Interactive comment on “A 2-D process-based model for suspended sediment dynamics: a first step towards ecological modeling” by F. M. Achete et al.

Received and published: 3 March 2015

Fig. 2.

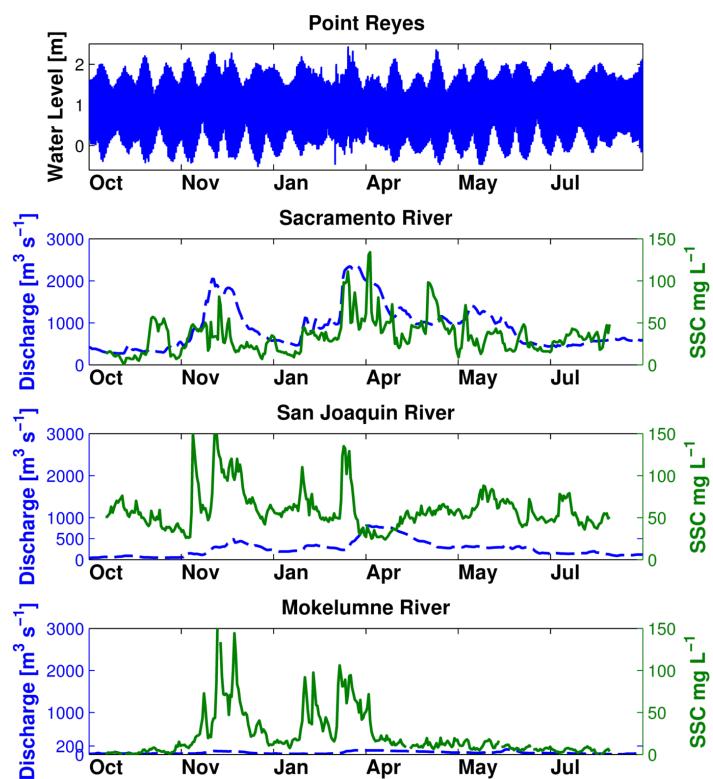
RC-Fig. 2 The labels and the location points of the calibration stations are too small. Please increase the font size.

AC-Figure updated.

Fig. 3.

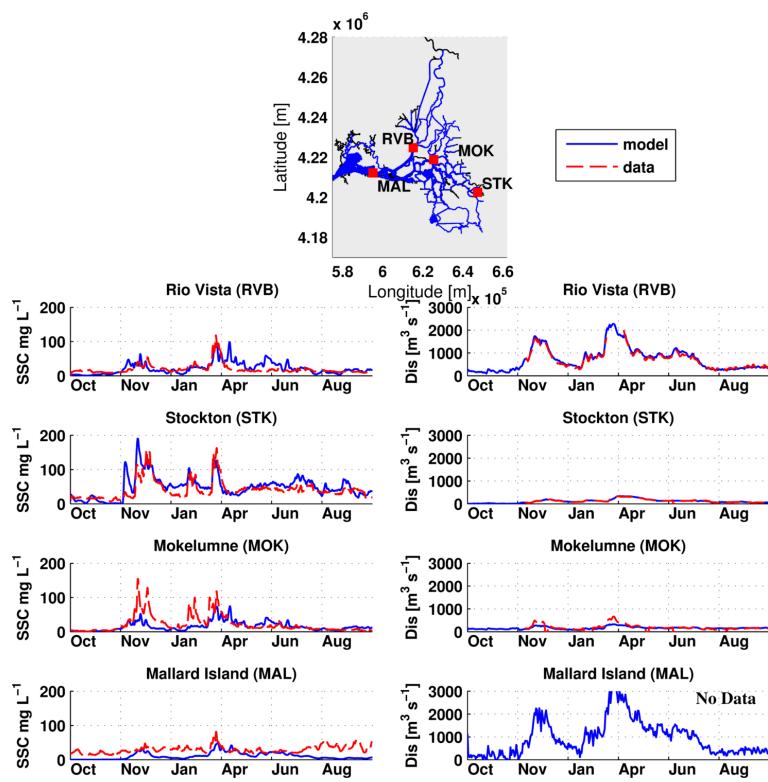
RC-Fig. 3: It is hardly visible that the blue line is dashed. The authors may increase the dash spacing or simply plot a blue line.

AC-Figure updated.
